## Product Change Notice (PCN)

PCN Number: **PCN-0450524R-01**

Product(s) Affected: *SJ-2523-SMT-TR, SJ-2524-SMT-TR*

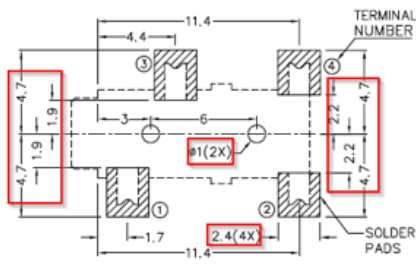
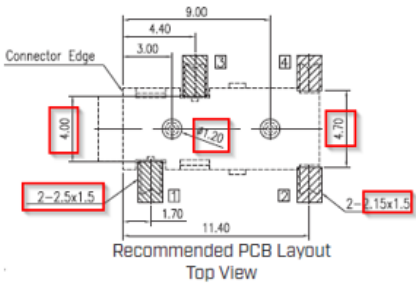
Reason(s) for Change: *Manufacturing process improvements*

PREVIOUS CUI DEVICES DETAIL / IMAGE	NEW CUI DEVICES DETAIL / IMAGE																																				
 <p>Recommended PCB Layout Top View</p>	 <p>Recommended PCB Layout Top View</p>																																				
<table border="1"> <thead> <tr> <th></th> <th>MATERIAL</th> <th>PLATING</th> </tr> </thead> <tbody> <tr> <td>terminal 1</td> <td>copper alloy</td> <td>silver</td> </tr> <tr> <td>terminal 2</td> <td>copper alloy</td> <td>silver</td> </tr> <tr> <td>terminal 3</td> <td>copper alloy</td> <td>silver</td> </tr> <tr> <td>terminal 4</td> <td>brass</td> <td>silver</td> </tr> <tr> <td>plastic</td> <td>PA6T or equivalent</td> <td></td> </tr> </tbody> </table>		MATERIAL	PLATING	terminal 1	copper alloy	silver	terminal 2	copper alloy	silver	terminal 3	copper alloy	silver	terminal 4	brass	silver	plastic	PA6T or equivalent		<table border="1"> <thead> <tr> <th>DESCRIPTION</th> <th>MATERIAL</th> <th>PLATING/COLOR</th> </tr> </thead> <tbody> <tr> <td>terminal 1</td> <td>phosphor bronze t=0.25</td> <td>silver over nickel</td> </tr> <tr> <td>terminal 2</td> <td>phosphor bronze t=0.30</td> <td>silver over nickel</td> </tr> <tr> <td>terminal 3</td> <td>phosphor bronze t=0.25</td> <td>silver over nickel</td> </tr> <tr> <td>terminal 4</td> <td>brass t=0.30</td> <td>silver over nickel</td> </tr> <tr> <td>housing</td> <td>PA10T (UL94V-0)</td> <td>black</td> </tr> </tbody> </table>	DESCRIPTION	MATERIAL	PLATING/COLOR	terminal 1	phosphor bronze t=0.25	silver over nickel	terminal 2	phosphor bronze t=0.30	silver over nickel	terminal 3	phosphor bronze t=0.25	silver over nickel	terminal 4	brass t=0.30	silver over nickel	housing	PA10T (UL94V-0)	black

MATERIAL	PLATING																																			
terminal 1	copper alloy	silver																																			
terminal 2	copper alloy	silver																																			
terminal 3	copper alloy	silver																																			
terminal 4	brass	silver																																			
plastic	PA6T or equivalent																																				
DESCRIPTION	MATERIAL	PLATING/COLOR																																			
terminal 1	phosphor bronze t=0.25	silver over nickel																																			
terminal 2	phosphor bronze t=0.30	silver over nickel																																			
terminal 3	phosphor bronze t=0.25	silver over nickel																																			
terminal 4	brass t=0.30	silver over nickel																																			
housing	PA10T (UL94V-0)	black
